Special inspection to increase the TBO for engine

- Subject:** Increase of TBO from 600^h/10 years to 1000^h/10 years.
- Engines affected:** Generally all engines of Series Type 912 A up to and including engine N. 4,380.693 in accordance with Type Certificate TW 8/89, with the exception of V912/1983, V912/1920, 3,792.605, 3,792.701, 3,792.788, 3,792.789, 3,792.790, 4,005.013, 4,005.083, 4,005.133. From engine N. 4,076.192 onwards the 1000^h TBO is covered by TM 912-04.

2.1) Friction washer, amendment no. 15:

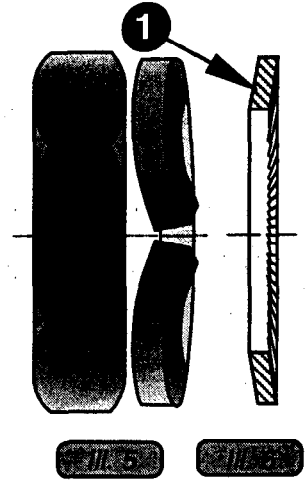
If hex. nut is still secured by a lock washer, it has to be exchanged for the friction washer ①. Slide drive gear of the exchange gearbox on cleaned serration of crankshaft and fit friction washer and hex. nut M30x1,5.

■ **ATTENTION:** Secure hex. nut with LOCTITE 221. Hex. nut with L.H. thread.

3) Oil pump amendment no. 17, 22 and 32-17:

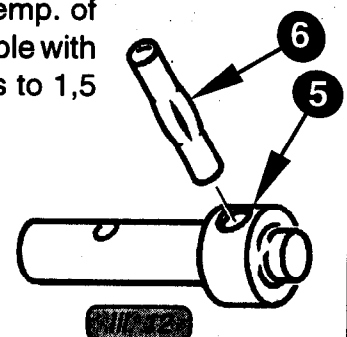
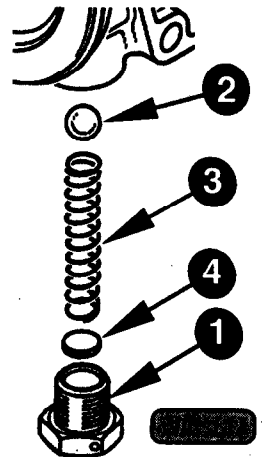
Remove plug screw ① of pressure relief valve ②, clean valve and check ball seat in housing. Clear all oil passages by compressed air. From engine serial no. 4,005.186 onwards, to improve oil pressure control the following parameters of the relief valve were changed. Free length of the compression spring ③ was reduced from 46 mm to 39,5 mm. Spring rate was changed by increase of wire dia. from 0,8 mm to 0,9 mm, and dia. of ball was increased from 8 mm to 8,5 mm.

◆ **NOTE:** Starting with engine N. 3,792.944 the oil pump housing and oil pump cover is in pressure die cast. On this occasion capacity of the pump was increased by lengthening of the rotary piston assy. from 13 mm to 16 mm along with the respective changes of oil pump housing, pump shaft and O-rings.

From engine serial no. 4,076.068 onward the follower in the oil pump shaft ⑤ was changed to notched pin ⑥ instead of the former dowel tube.

If existing, remove shim ④, but if specified oil pressure can't be reached, adjust pressure by adding shim again.

At a renewal of components change oil pump to the version with the 16 mm long rotors.

5) Water pump, amendment no. 35-02

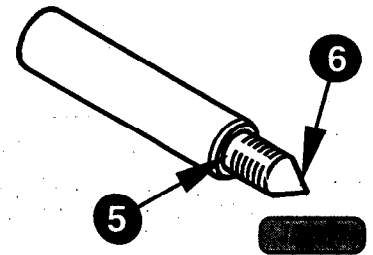
At engine operation without antifreeze in the coolant, increased formation of corrosion takes place. Therefore the material of the pump shaft was changed with engine serial no. 4,076.122. Because of galvanic reactions, caused by the use of various materials, the washer ① and the screw ② are of stainless steel since engine serial no. 4,076.178.

Check water pump shaft at runout of thread ⑤ for possibly existing corrosion. At bad corrosion renew water pump shaft. For this renewal remove ignition housing and fit new water pump shaft as per instructions in the Repair Manual.

u Note: The new shaft can be recognised by a taper ⑥.

6) Carburettor

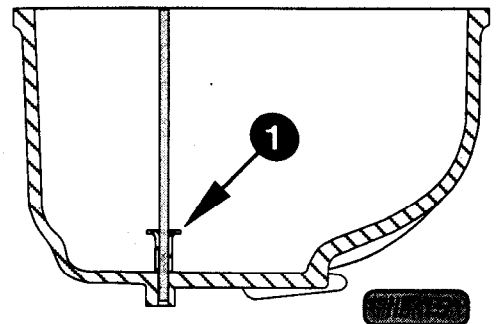
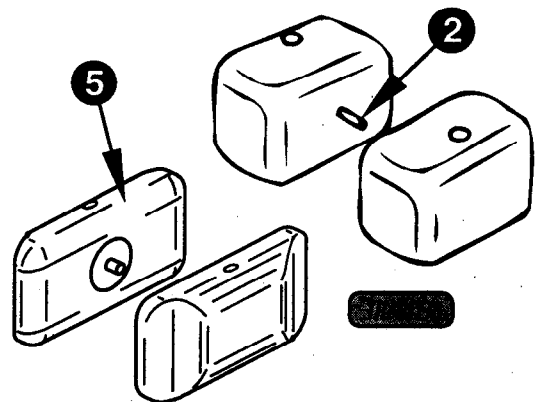
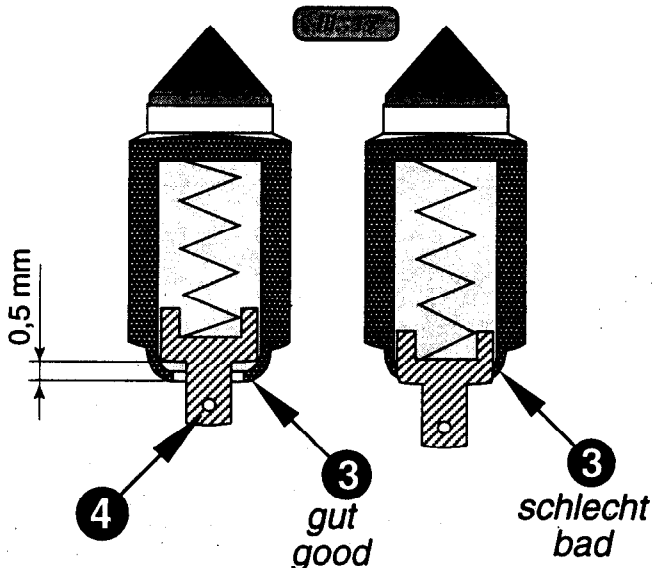
Remove float chamber and lift out both floats. If float chamber is still without distance pieces ①, part no. 861 920, add them now, thus avoiding possible sticking of the floats in the float chamber.

Check support pin ② of floats. At heavy wear of float bracket contact faces, caused by excessive vibration, exchange these floats to floats of modified shape ⑤, part no. 861 181 as per amendment no. 37-01 and renew float bracket as required.

Examine float valve with float chamber removed. At noticeable wear of beaded edge ③ at the sprung pin ④ the valve has to be renewed. If the distance becomes less than 0,5 mm (see ill. 17) the float level will be effected too.
